DEPARTMENT OF GENERAL PLANNING
CITY AND COUNTY OF HONOLULU

Final Environmental Impact Statement (FEIS)
for the Lanikai Flood Control Project, Phase I
Tax Map Key: 4-3-03 thru 05

CHAPTER 343, HRS
ENVIRONMENTAL IMPACT STATEMENT (EIS)
LANIKAI FLOOD CONTROL PROJECT
(PHASE I CONSTRUCTION)
DEPARTMENT OF PUBLIC WORKS, DIVISION
OF ENGINEERING, C&C OF HONOLULU
KAILUA, KOOLAUPOKO, OAHU
TAX MAP KEY 4-3-03 THRU 05

FIGURE 3

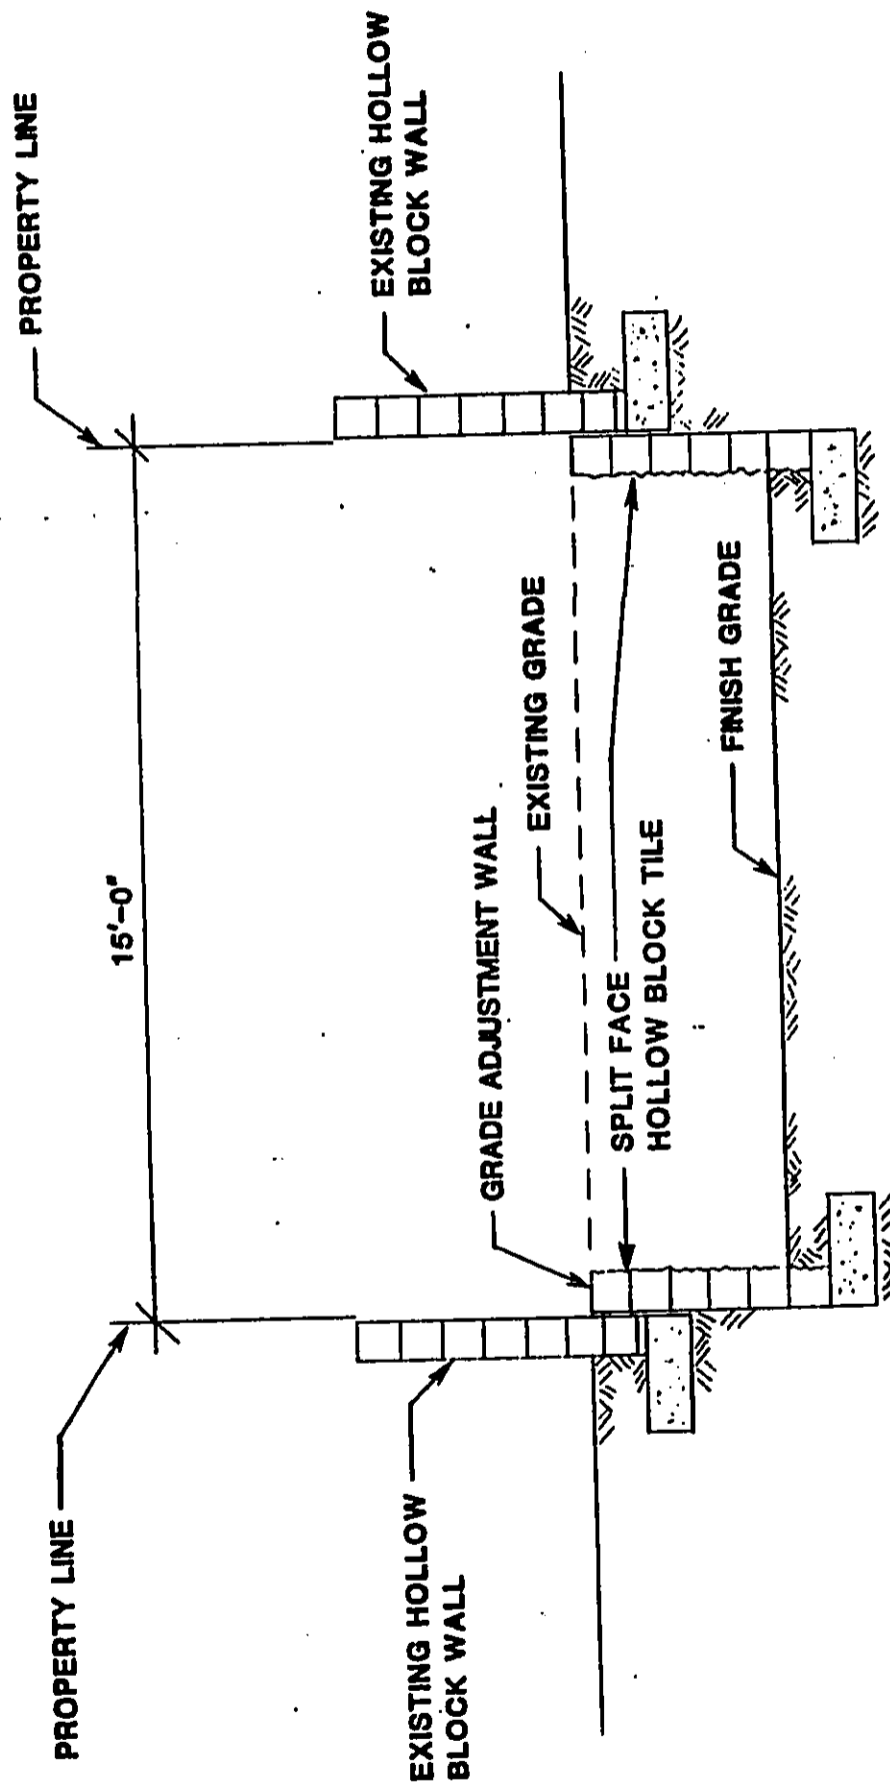
As shown in Figure 3, large areas within the project area are presently undeveloped, and contain potential future house lots which will have to be added to the drainage system. It is not clear from statements in the Draft EIS whether the proposed improved drainage system will be capable of handling additional drainage from future development.

The proposed project will be in proximity to existing HECO elec-
trical facilities (see Attachment 1, Figure 3 in the EIS). Our
review shows that a number of possible conflicts with the project
and HECO facilities may exist throughout the project area. Re-
solving these conflicts will require HECO engineering. The devel-
oper or his consultant is to complete the coordination of their
work with HECO prior to finalizing the project design.

TYPICAL OVERFLOW SWALE AT
BEACH RIGHT OF WAY

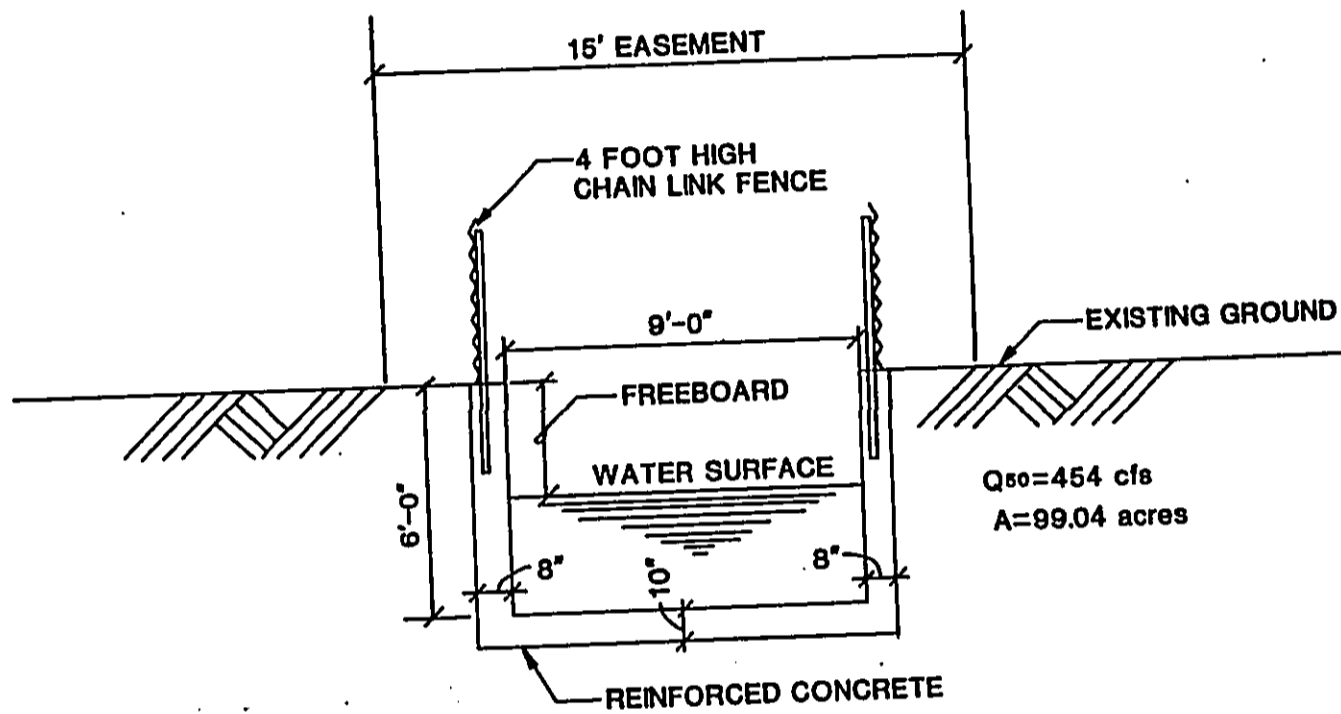
Figure 4 shows a "Typical Overflow Swale at Beach Right of Way". The swale is depicted as being constructed of monolithic walls and floor of reinforced concrete with a maximum wall height of 4'-6". This figure is incorrect in that, as designed, the maximum wall height is 7'. Nowhere in the EIS is the general appearance or alternate design of these swales discussed as Mr. Thiede's reply indicated they would. The EIS is deficient in this regard and the current design is unacceptable to the Lanikai community. It should be noted that a meeting was held on April 19, 1989 with Mr. Sam Callejo, Director, Department of Public Works, representative of Councilperson Kahana's Office, Kwack Associates and representatives of the LFCP Steering Committee and the President of the Lanikai Community Association. At this meeting Mr. Callejo agreed to review the design of the swales in order to minimize their visual impact. It is therefore assumed the issue of swale design can be resolved by this cooperative effort.

SECTION-OPEN CHANNEL EXTENSION

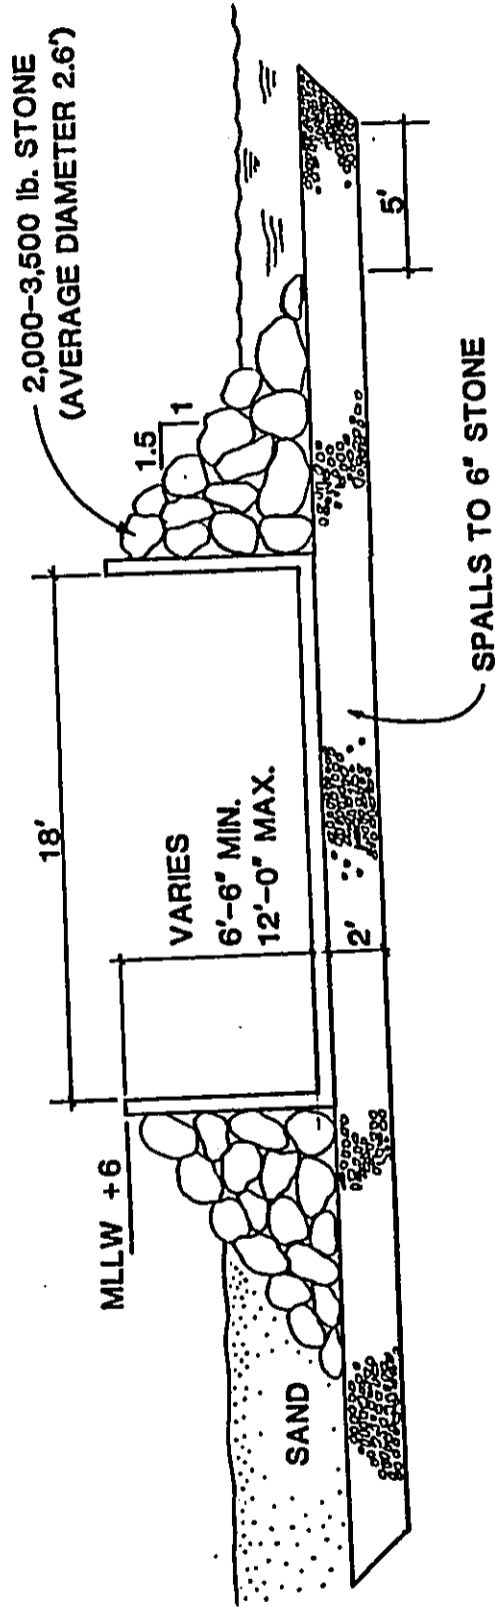
Page 17, Figure 4: Figure 4 shows a cross section of the open channel extension and we note that a vertical drop of six feet to a concrete channel floor is indicated. Considering that this will be present across a public sand beach area, we believe that this structure represents a significant safety hazard, especially to children. With the vertical concrete walls proposed, great difficulty would be experienced in climbing out of the channel if one fell in, not to mention the danger of the fall itself. Fencing will be required unless some other method of enclosing the channel is proposed. Visual impacts of the solutions to this safety problem should be considered particularly since the activity will take place in a sensitive coastal recreational area.
